**Re: Opus Transport Apartment**  
**2900 Transport St. SE**  
**Traffic Circulation Layout**  
Engineer's Stamp 08-16-24 (M15-D023H)

**RE: 2023065 TRANSPORT APARTMENTS – OPUS  
2900 TRANSPORT ST. SE  
TRAFFIC CIRCULATION LAYOUT**

ENGINEER'S SEAL	TRANSPORT APARTMENTS ALBUQUERQUE, NM	DRAWN BY SB
RONALD R. BOHANNAN 7868 PROFESSIONAL ENGINEER	TRAFFIC CIRCULATION LAYOUT	DATE 07/03/24
	TERRA WEST, LLC 5571 MIDWAY PARK PL NE ALBUQUERQUE, NEW MEXICO 87109 (505) 858-3100 www.tierwestllc.com	DRAWING
08/16/2024		SHEET # TCL-1
RONALD R. BOHANNAN P.E. #7868		JOB # 2023065

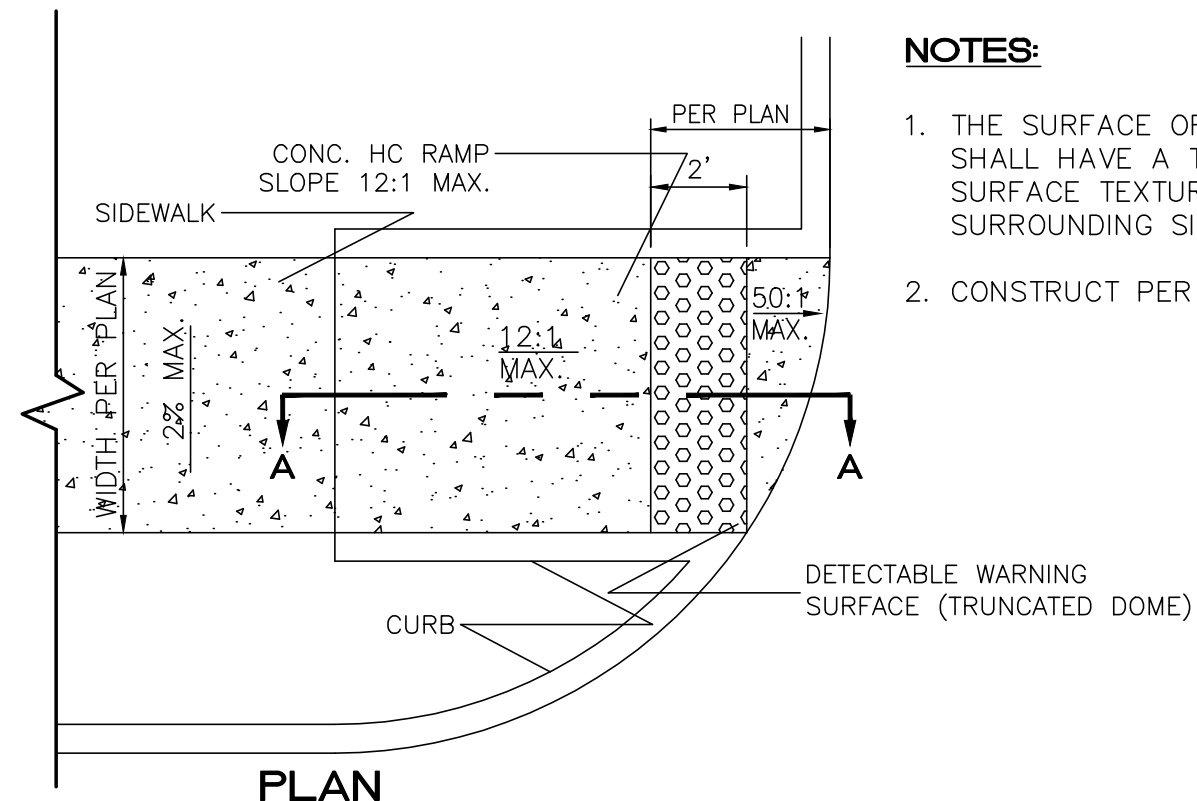
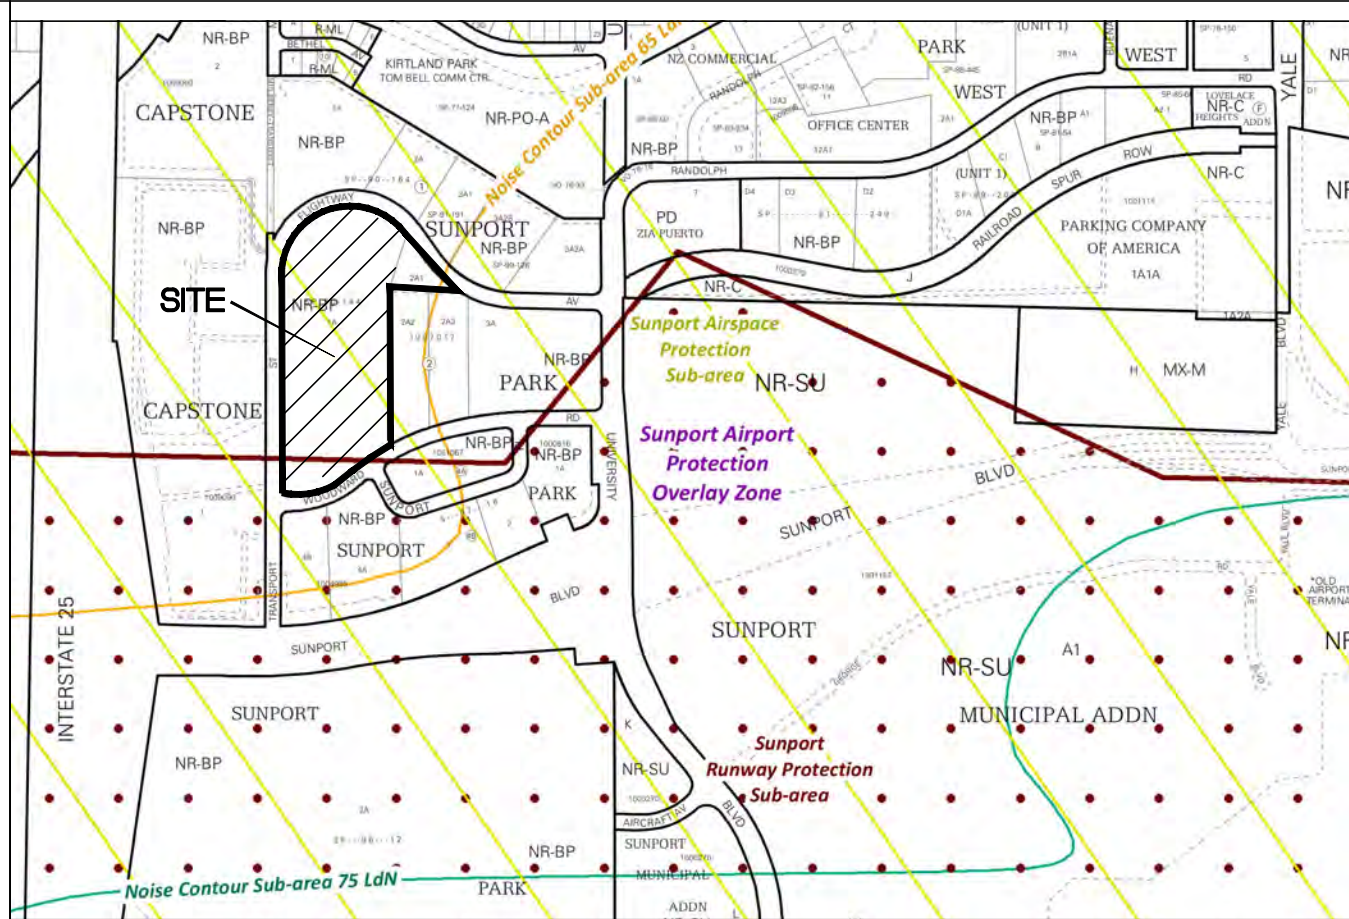
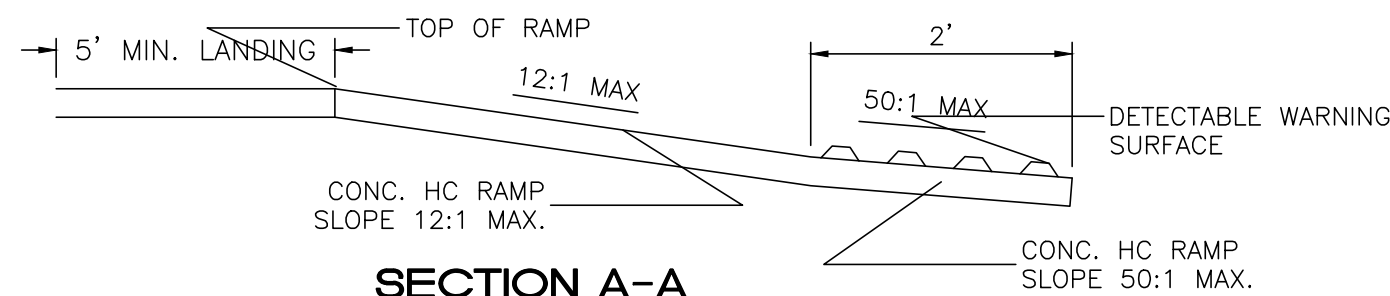
1. Identify the right of way width, medians, curb cuts, and street widths on Transport St. and Woodward Rd. SE.

3. Per the DPM, please indicate a minimum throat length of 75 ft for both site accesses.

4. Drawing is missing keynote 2.

5. Are you providing EV parking spaces less than the required number? Please address this concern.

6. Provide proposed standard parking spaces width.

7. Parking spaces at the east side of building A are out of the property

8. Key note 10: is it a median?

9. Please provide details for the sidewalk in this area.

10. Please show on the site plan the width of the ADA pathway from the public sidewalk to the building entrance.

11. Key note 13: Due to proposing a gate, please provide vehicle turning around template.

**RESPONSE: Acknowledged, see TCL plan for dimensions.**

**RESPONSE: Length greater than 75 ft, discard per Marwa.**

**RESPONSE: Keynote 2 was added and indicates the southwest corner ramp.**

**RESPONSE: Minimum requirements are now met,**

**RESPONSE: Acknowledged, see TCL plan for dimensions parking stall dimensions vary depending on the location.**

**RESPONSE: That property will also be owned by the developer. A parking**

**easement can be provided prior to final CO.**

**RESPONSE: Keynote 11 is a median for the gate keypad.**

**RESPONSE: Acknowledged, see TCL plan for dimensions.**

**RESPONSE: The ADA path to the front of the building(s) is 6 ft wide.**

**RESPONSE: Acknowledged, the south entrance was widened to allow vehicle turn around.**

CORNER RAMP DETAIL (TYP.)  
NTS

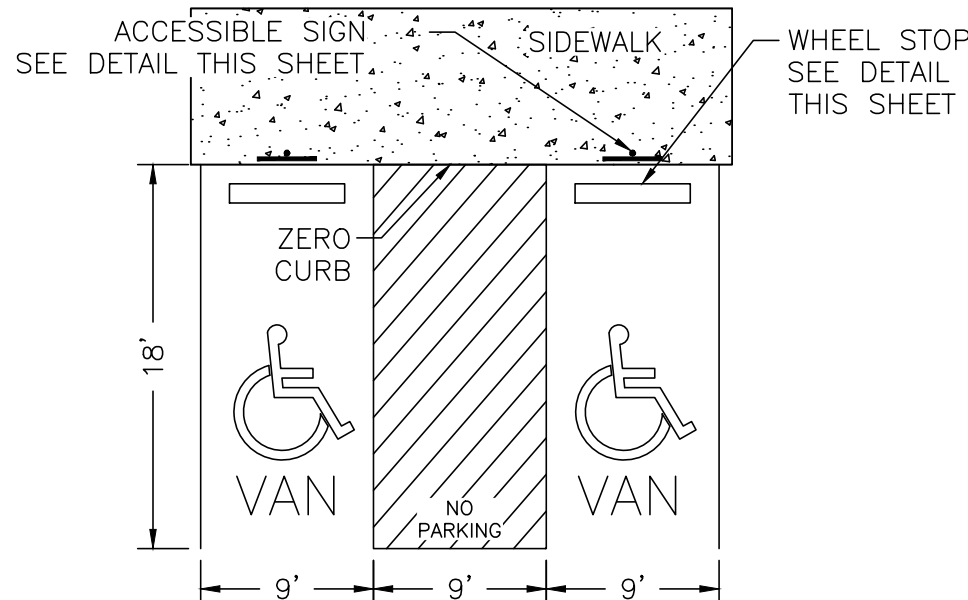
- Proposed ADA ramp at the corner of Transport St. and Woodward Rd. details.

**RESPONSE: Acknowledged, see TCL plan for dimensions.**
